SERVICE BULLETIN

MODEL NAME : Di620
MODEL CODE : 1155
NO. : 029
DATE : 990310
SUBJECT : BUSHING CHANGE

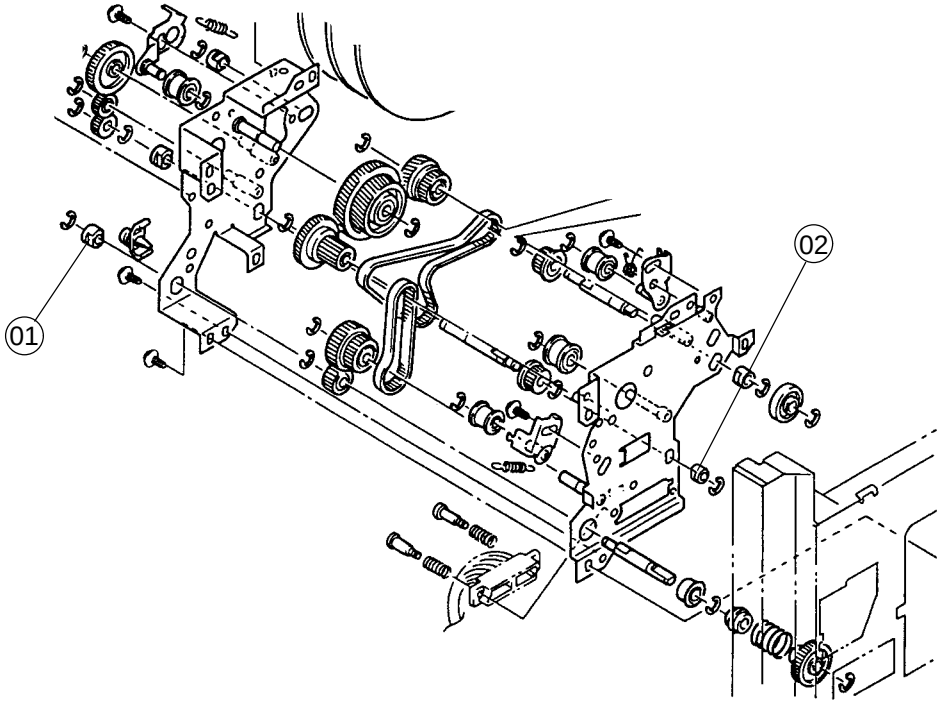
The material for bushing A (01) has been changed from plastic to metal. This prevents noise from occurring due to vibration while the copier is being driven.

The material for bushing B (02) has not been changed because bushing B (02) is not affected by vibration.
